## ArgonCube LBNC

Near Detector Workshop  
May 26<sup>th</sup> 2019

# Response to Specific comments

Figure 1.6: (a) A prototype ArgonCube light readout paddle. The paddle is 50 cm long and 10 cm wide, with four SiPMs coupled to one end. Reproduced from Ref. [?]. (b) ArCLight paddle mounted on the PixLAr pixelated charge readout plane, as used in test beam studies at Fermilab.

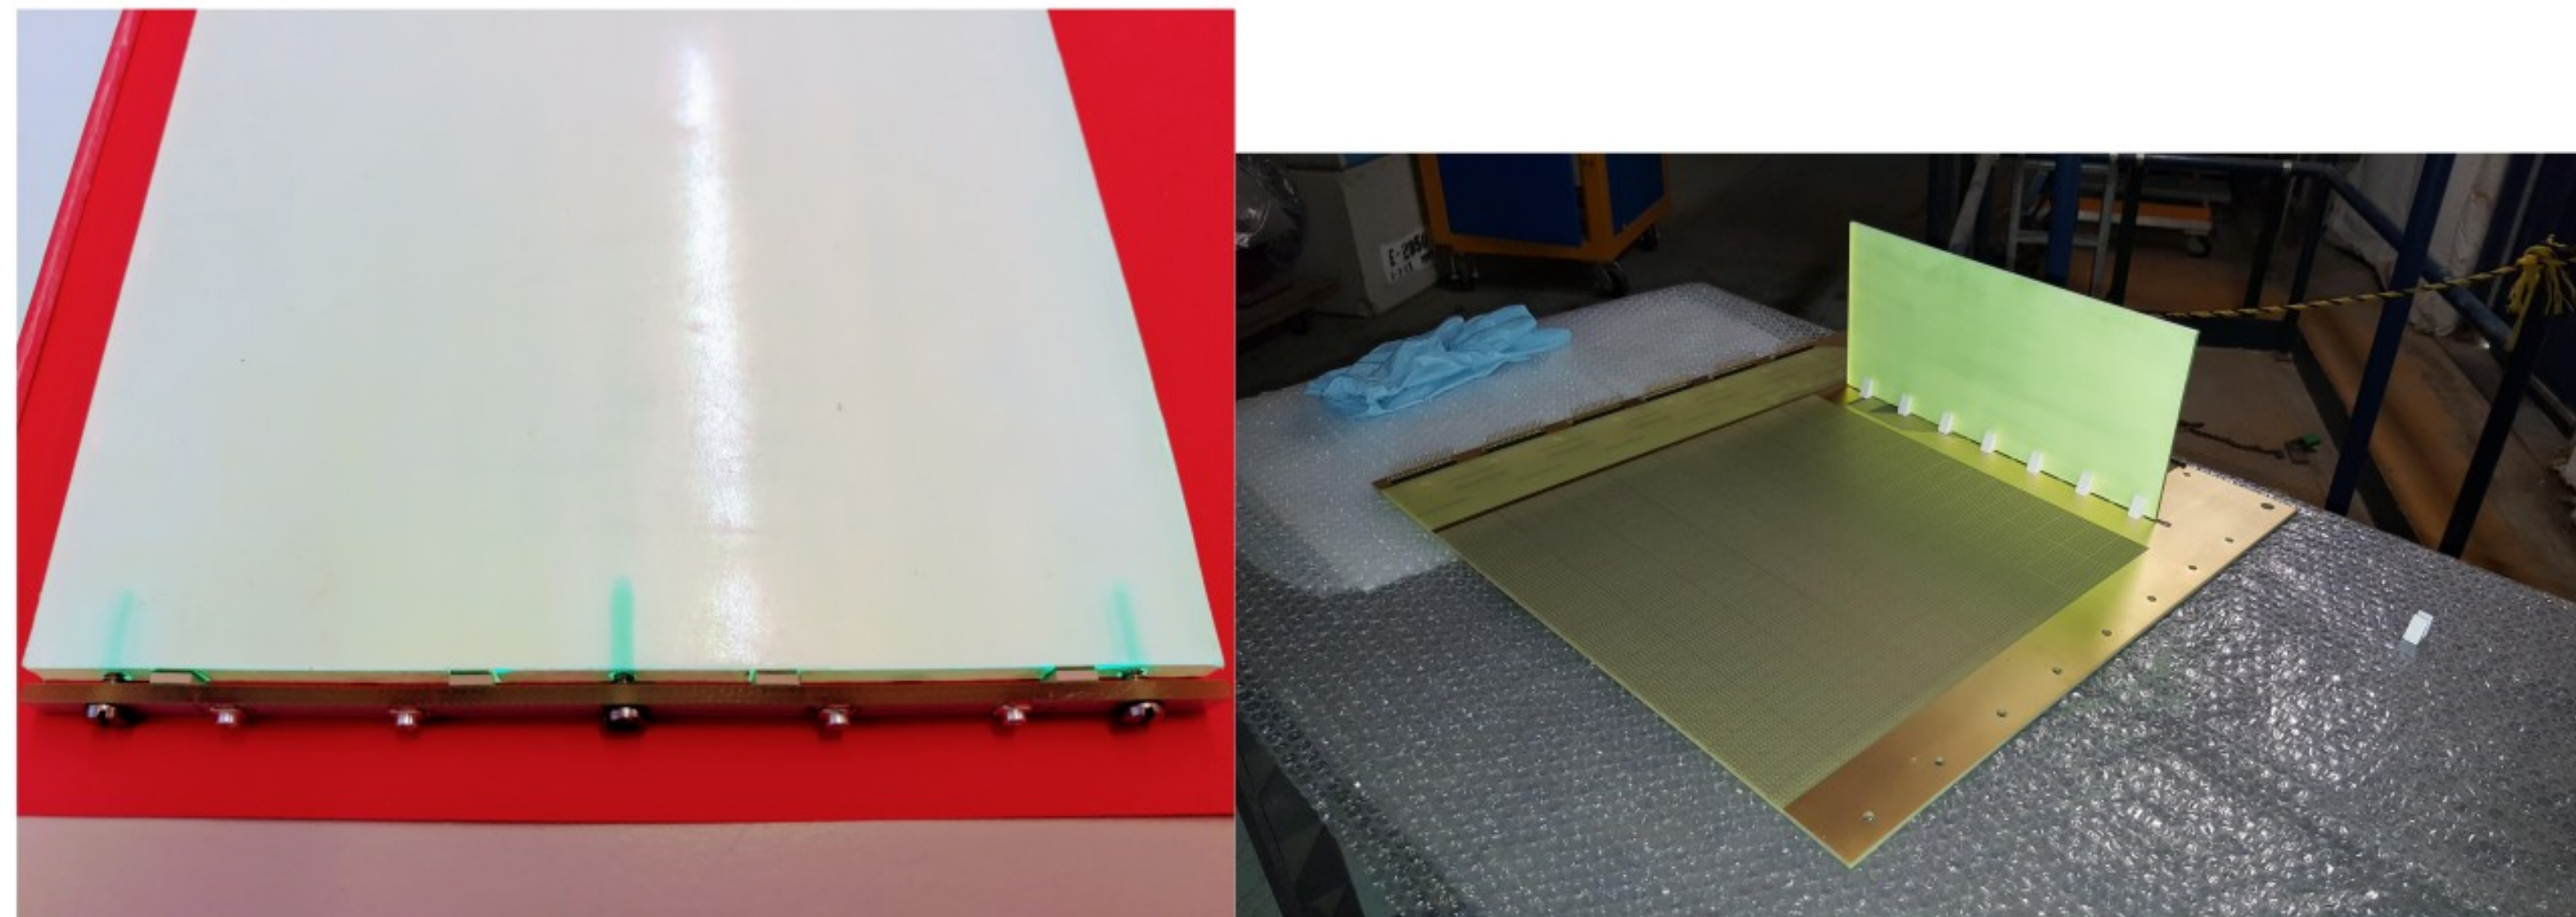
E-field with ArClight (11)

This was done in PixLAr, see Figure 1.6 (b)
